SECOND REVIEW
WC³ Project #: 219-525-088
Weber County

Subject: SMHG LLC - Pioneer Cabin – Plan Review Comments 2nd Review

Project Name: SMHG LLC - Pioneer Cabin
Location(s): 7860 East Horizon Run, Eden, UT

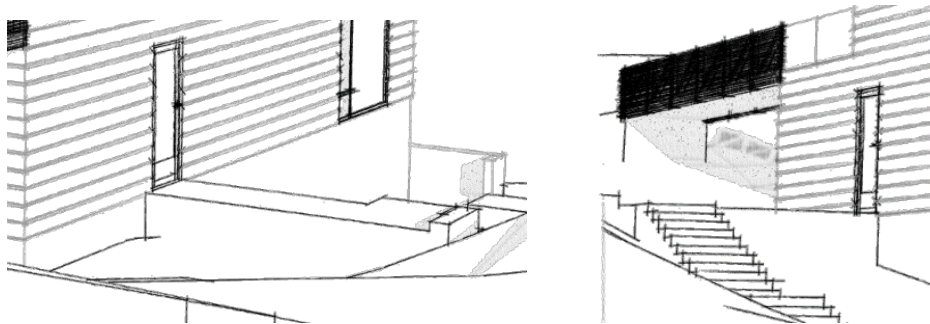
B. Due to the grade you are proposing this is a 3-story building. As such Table 504.4 only allows a 1-story building. With sprinklers you could be 2-stories, but unless Type 5-A construction is proposed there is no way to build as shown with a 3-story configuration.

- A6. Sheet 1.1: Please address the following:**

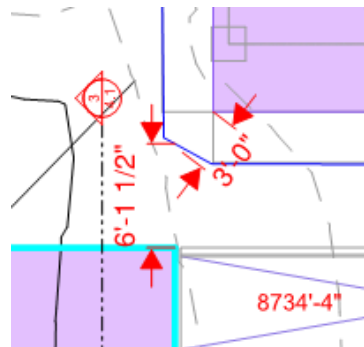
A. Please provide a site plan showing the location of the building on the site and its distance from property lines and other structures as required by IBC 107.2.5. The following items should also be included:

- I. The north east corner of the building will be 5-10' from the imaginary line separating the cabin from the adjacent residential unit. As such Per Table 705.8 only 10% unprotected openings are permitted, and per IBC Table 602, a portion of the wall must be 1 hr. rated on (both sides). As this is problematic with your current design, consider moving the building to the west 10" and eliminating the issue as measurements are taken at right angles to the exterior walls.**

A7. Sheet 2.1: Please address the following:

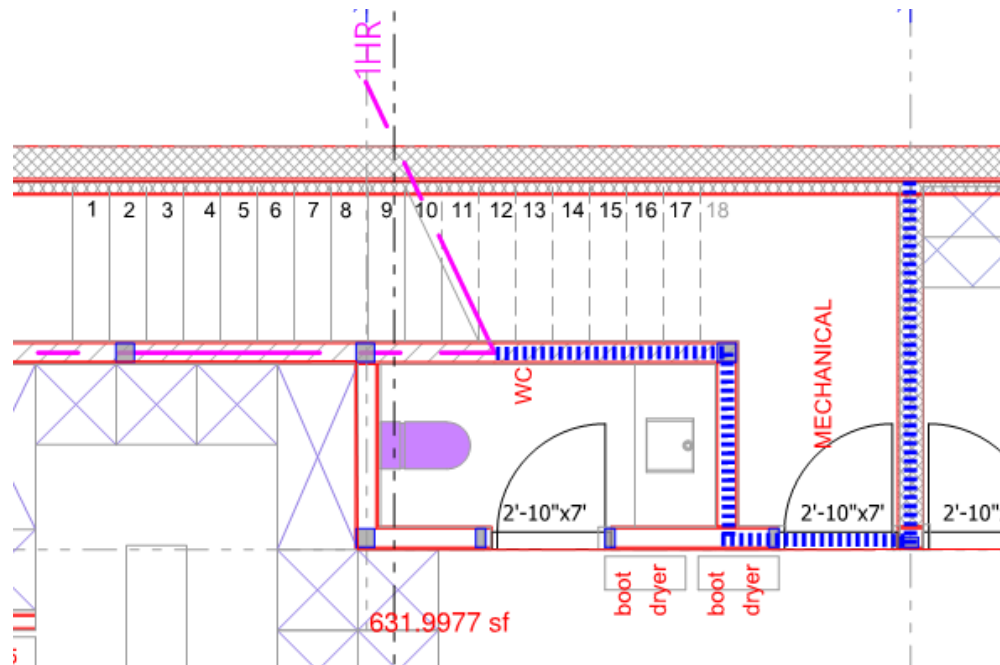
- A. Provide details for all stairs showing handrail extensions at the top and bottom of all stairs, on both sides. IBC 1014.6**
- B. The 1 hr. rated walls must be continuous from the foundation to the roof deck. This will required that the 1 hr. rated walls on the main level be continued in the same plane on the lower level.**

- C. Show rated doors into all proposed rated stair enclosures as per IBC 716. As these are 1 hr. rated fire barriers, a minimum door rated for 45 min, with closers is required.**
- D. Please review the continuity requirements for fire barriers found in IBC 707.5. The proposed stair enclosures do not stack level to level. The fire barriers must be continuous through concealed spaces as well. The areas in green show the stair enclosures at the levels above. (Additional 1-hr. rated walls shown in dashed blue lines)**
 - I. This also applies to the roof/ceiling assembly at the upper level. (The ceiling of the stair enclosure)**

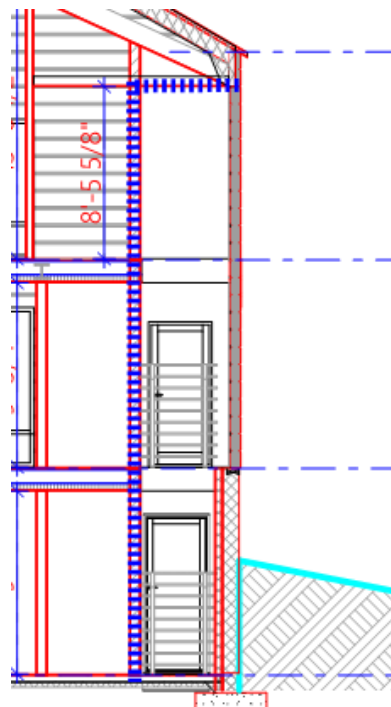
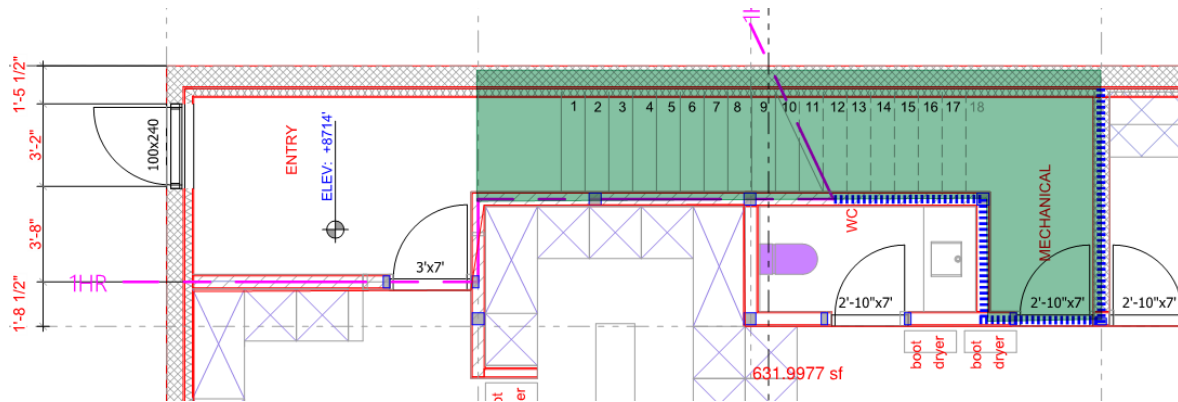
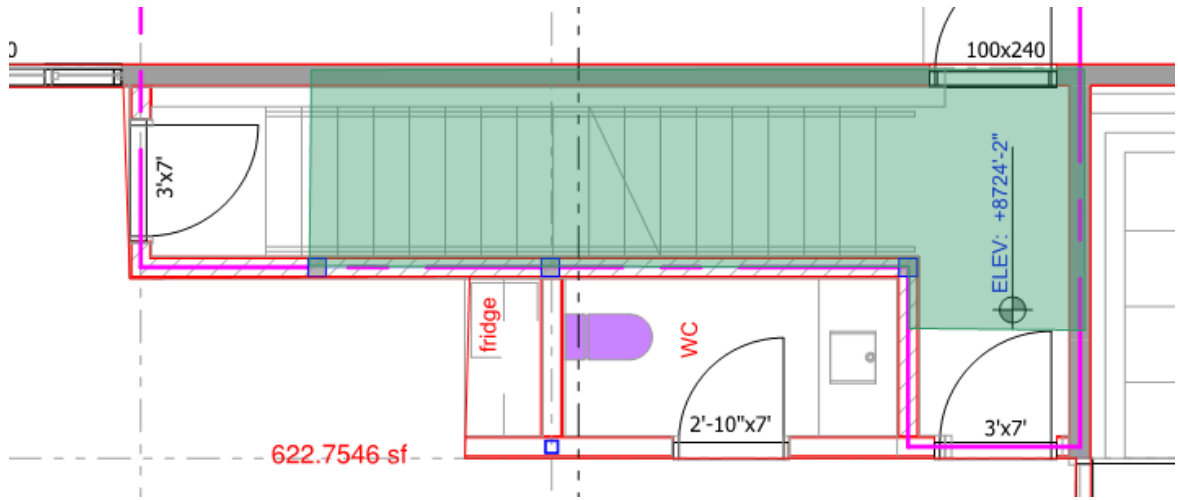
- E.** The areas not highlighted in green will also require a 1 hr. rated floor/ceiling assembly. The provided plans provide no information regarding the method in which the 1 hr. rated fire barrier will be constructed. Please provide listed assemblies for the walls, and the proposed floor/ceiling assembly.
- F.** The proposed fire barriers are also limited with respect to penetrations. i.e. the wood framing for floor joists, beams, etc. can't penetrate the assembly. (select examples below)
